Discontinuation Notice of USB-Infrared Conversion Cable Model E58-CIFIR, optional product of Advanced Digital Temperature Controller Model E5AN-H/E5EN-H series.

Modifications Notices

No. 2021018AE

Modification Notice of design change which eliminates the infrared communication function of Advanced Digital Temperature Controller Model E5AN-H/E5EN-H series due to discontinuation of USB-Infrared Conversion Cable Model E58-CIFIR.

Product discontinuation	Recommended replacement
E58-CIFIR	E58-CIFQ1

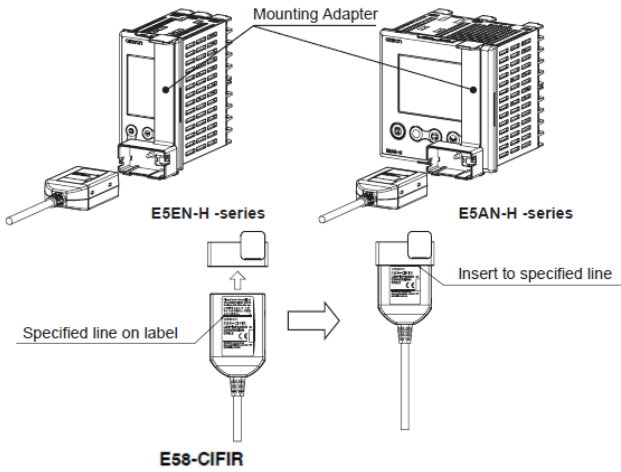
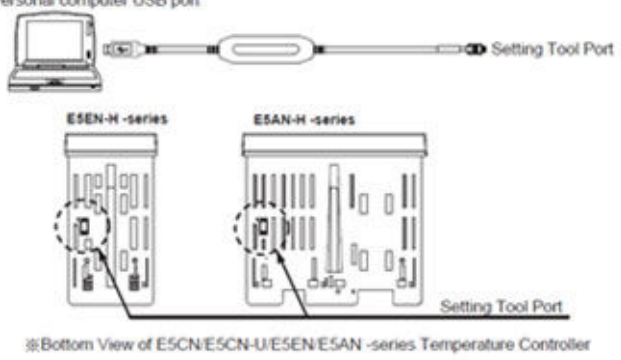
Product discontinuation Model E58-CIFIR	Recommendable replacement Model E58-CIFQ1
Black 	Black (Change the shape)

Product discontinuation Model E58-CIFIR	Recommendable replacement Model E58-CIFQ1
Model E5EN-H series or E5AN-H series ●Connecting to the Temperature Controller  Connection to product •Use infrared communication.	Model E5EN-H series or E5AN-H series ●Connecting to the Temperature Controller Personal computer USB port  Connection to product •Use connector communication.

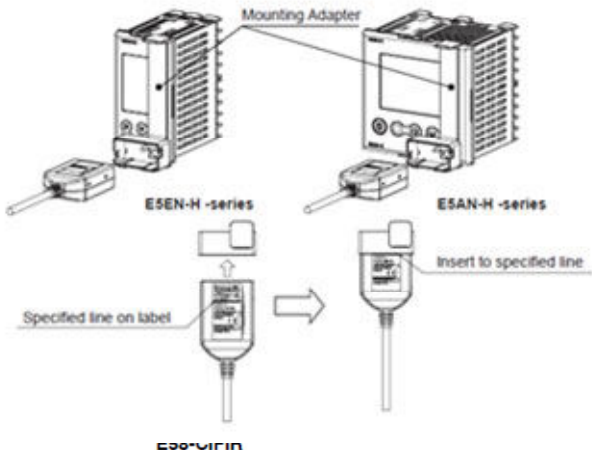
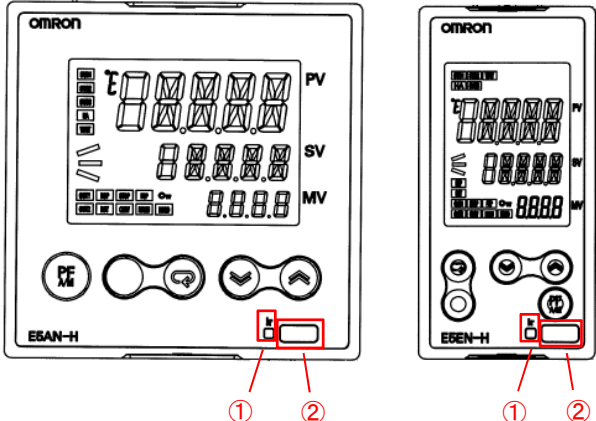
Before the change	After the change
Infrared communication The communication is enabled on the front, with infrared port using Model E58-CIFIR. • Infrared communication between Model E5AN-H/E5EN-H series and Model E58-CIFIR. 	Infrared communication The communication is disabled on the front, with infrared port using Model E58-CIFIR.

Before the change	After the change
Front panel ① Infrared communications enabled indication: Yes ② Infrared communications receiver: Yes 	Front panel ① Infrared communications enabled indication: Delete ② Infrared communications receiver: Delete 
Instruction manual Description regarding infrared communication: Yes	Instruction manual Description regarding infrared communication: Delete
